802.3ck D1.4 Annex 162B – Test Fixtures FOM_{ILD} Comments

802.3ck Task Force

Comments Mated Test Fixture FOM_{ILD}

Proposal (A) Mated Test Fixture FOM_{ILD}

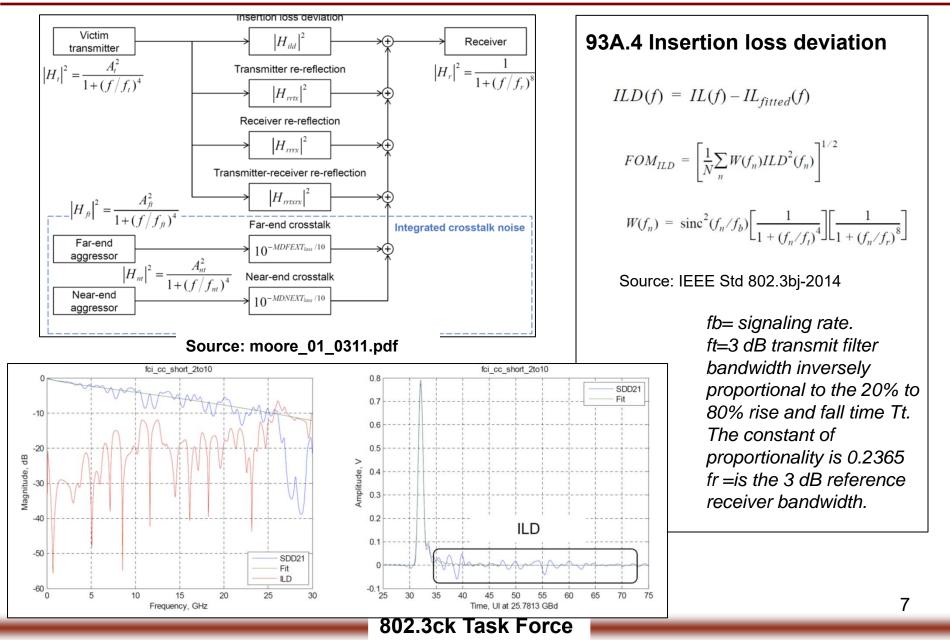
- FOM_{ILD} is an electrical specification related to <u>electrical properties</u> of MTF.
- 802.3ck has 6 host receptacles and plugs to consider (MTF).
- Comment#85 was resolved with the module output transition time (min) to 8.5 ps
- For 50G MTF FOM_{ILD} Tt=9.6ps, C2M (120E) Module Output @ TP4 Transition time (min, 20% to 80%) = 9.5ps (min)
- Proposal (A) MTF FOM_{ILD} = 0.18 dB, Tt=8.5 ps

Proposal (B) Delete MTF FOM_{ILD}

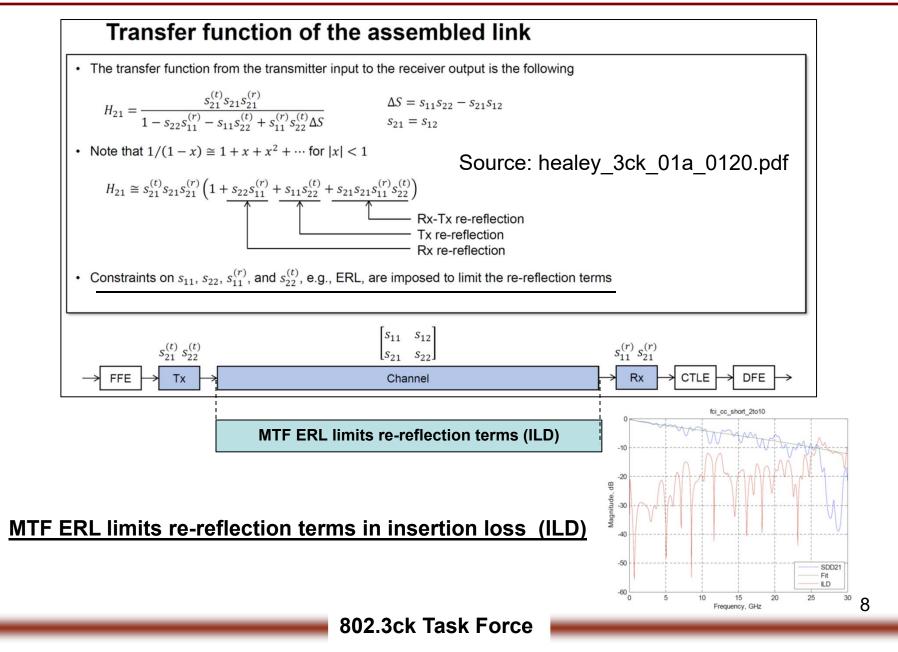
CI 162B SC 162B.1.3.1 P 262 L 36 # 130 Comment Type TR (addressing TBD) "FOMILD shall be less than (TBD) dB" The importance of this parameter for quality of test fixtures in the context of this project has not been presented. <u>ERL likely covers what FOMILD originally intended to cover.</u> The specification should be deleted without loss of technical completeness. SuggestedRemedy Delete the quoted sentence. PROPOSED ACCEPT IN PRINCIPLE. Resolve using the response to comment#111.

Proposal (A) Mated Test Fixture FOM_{ILD}

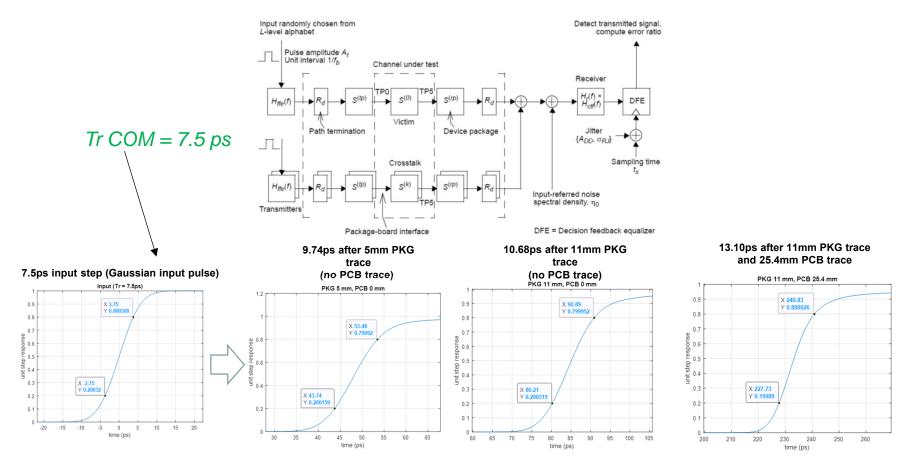
- 162B.1.3.1 P262, L36, TBD = 0.18 dB, T_t=8.5 ps
- Update PICs.
